2nd ADDENDUM
STAFF REPORT

CASE NUMBER: **P. D. 08-306 CC** **L.U.C.B. MEETING:** **April 9, 2009**
Held from March 12, 2009

DEVELOPMENT: **CANALE GROVE PLANNED DEVELOPMENT**

<h1 style="text-align: center;">OUTLINE PLAN</h1> <h2 style="text-align: center;">CANAL GROVE P.D.</h2>		
<u>PAYEE NUMBER:</u>		<u>CASE NUMBER:</u>
<h3><u>SHELLEY COUNTY TENNESSEE</u></h3>		
<u>RAMBER LOT#</u> <u>101.00 = TOTAL ACRES</u>	<u>NUMBER OF ACRES TO BE PAID TO THE</u> <u>STATE OF TENNESSEE, TENNESSEE, AND</u>	
<u>OWNER:</u> <u>SHIRLEY GUNNE PROPERTIES LLC</u> <u>7017 COUNTRY HILL DRIVE</u> <u>MEMPHIS TN 38125</u> <u>OR 901 724 5454</u>	<u>THE REASONS FOR</u> <u>OWNERS REQUEST FOR AWARD</u> <u>MEMPHIS TN 38125</u> <u>(0001) 781-2001</u>	
<u>2018</u>	<u>457152.0000 F</u>	<u>30 NOVEMBER 2017</u>
<u>17 JULY 2008</u>	<u>SCALE: 1" = 20'</u>	<u>SHEET 1 OF 5</u>

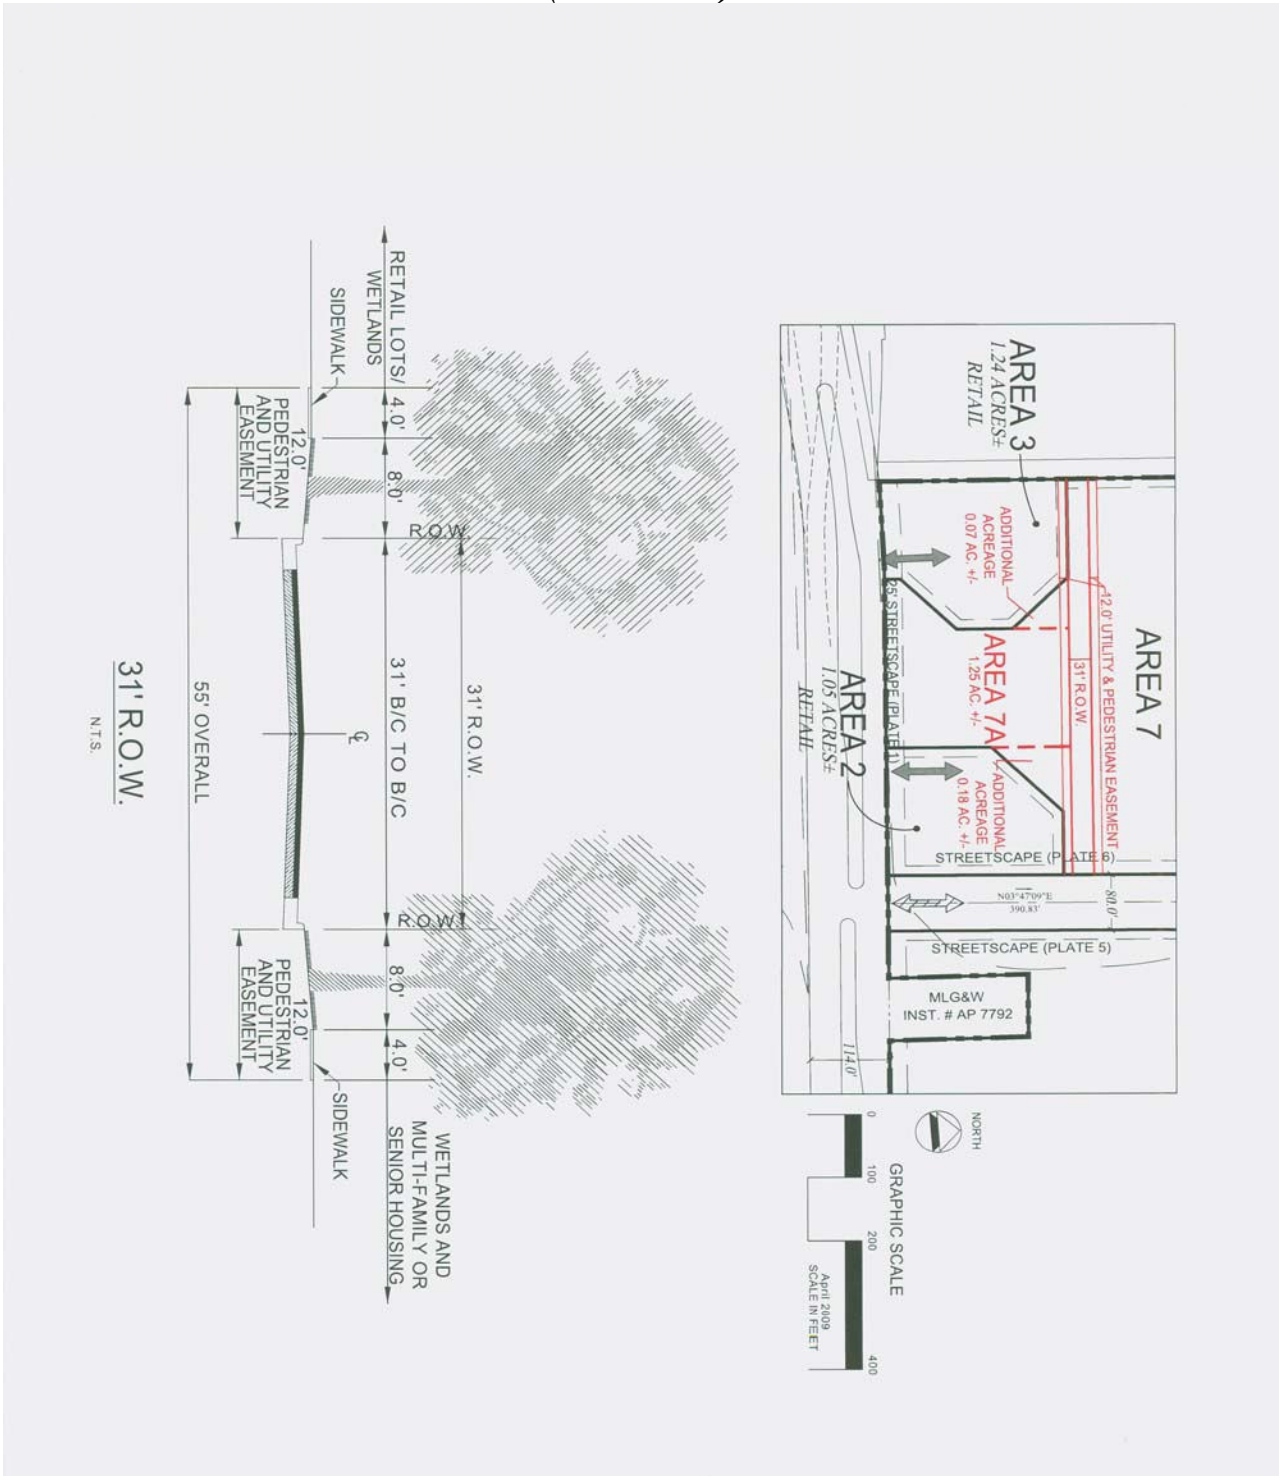
The applicant is providing a thirty-one(31) wide public road connecting Canale Grove Parkway and the approved public roadway in Woodland Hills II Outline Plan. The road will be located along the north property lines of 'Areas 2 and 3' of the Outline Plan which will modify the amount of acreage in these commercial areas. The public road connection creates a new 'Area 7-A' which will be used for a complex sign to identify the multifamily apartment/senior living retirement community in 'Area 7' of the Outline Plan.

The pedestrian crosswalks will be identified by pavement patterns or markings that are easily accessible by pedestrians. The applicant is also providing a thirty(30) foot wide Landscape Screen 'N-1' (modified) to include a sight-proof wood fence eight(8) feet in height along the north property line. The existing trees and vegetation within this buffer zone will be preserved and supplemented with cedar trees to fill voids in the landscape screen. The modifications and clarifications by the applicant have been provided to staff in the project review.
